Compton Community College District Geotechnical and Soils Investigation Report For Instructional Building #2

- 1. Original Report Prepared by United-Heider Inspection Group dated February 21, 2018
- 2. CGS First review letter dated April 25, 2018
- 3. United-Heider Response to CGS first review letter dated May 8, 2018
- 4. CGS Second review letter dated May 21, 2018
- 5. United-Heider Response to CGS second review letter dated June 15, 2018
- 6. CGS Third review letter & approval dated July 30, 2018

PRELIMINARY GEOTECHNICAL INVESTIGATION REPORT PROPOSED NEW INSTRUCTIONAL BUILDING #2 EL CAMINO COLLEGE COMPTON CENTER CAMPUS 1111 E. ARTESIA BLVD. COMPTON, CA 90221

Re: CGS Application No. 03-CGS3321
RESPONSE TO REVIEW COMMENTS

Figure 7 - Geotechnical Cross Section A-A'

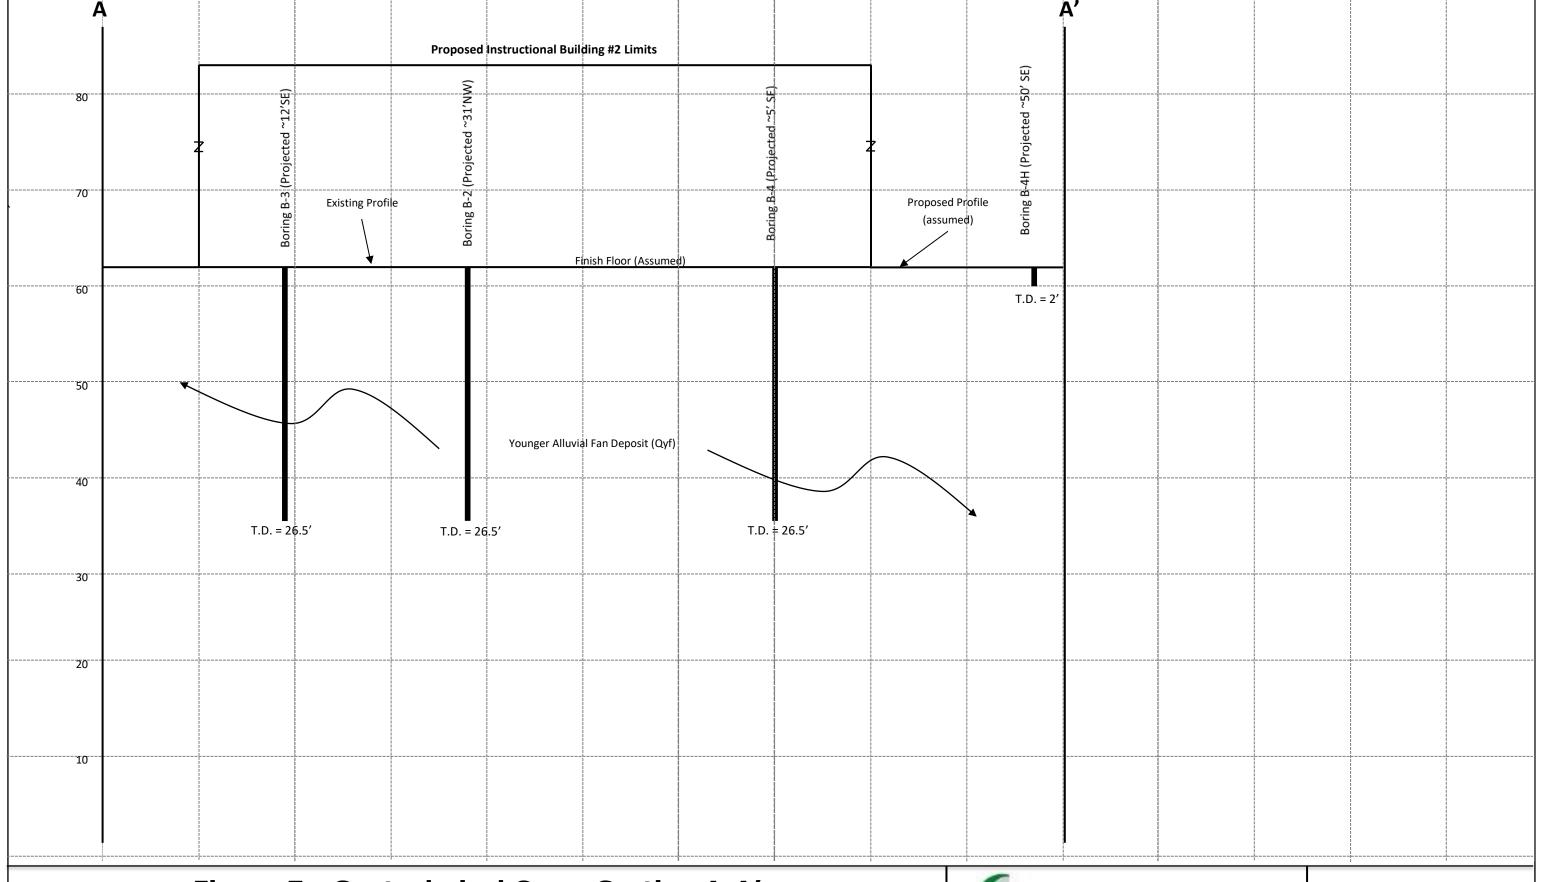
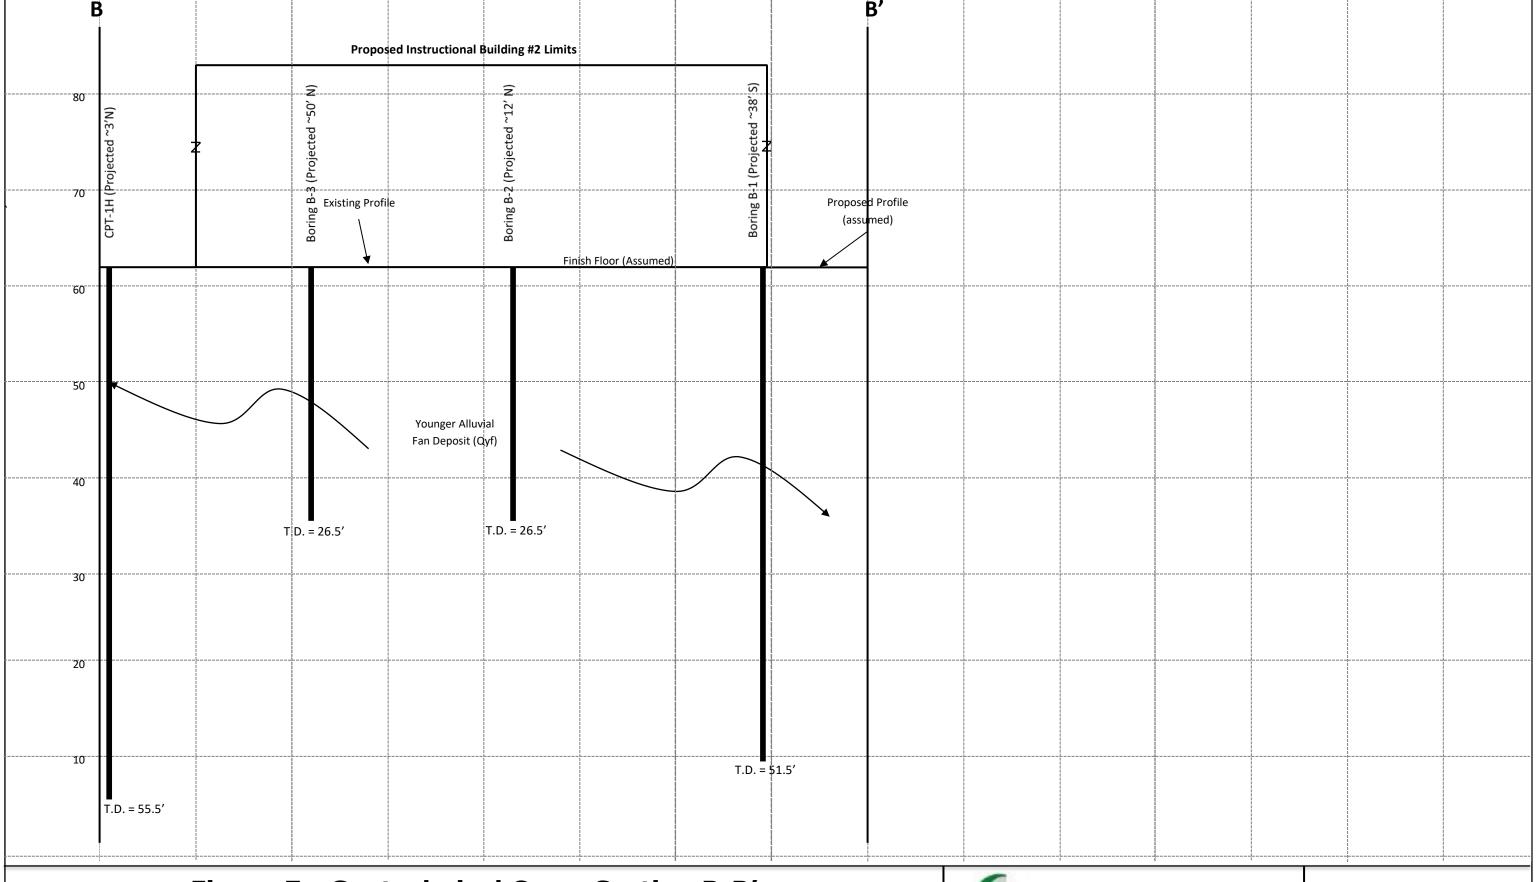
- 7. Geologic Cross Sections: Marginally adequate. The consultants present two "Geotechnical Cross Sections" depicting minimal geologic information. In the future, the consultants should provide geologic cross sections depicting additional subsurface soil information, and include foundation and site grading details.
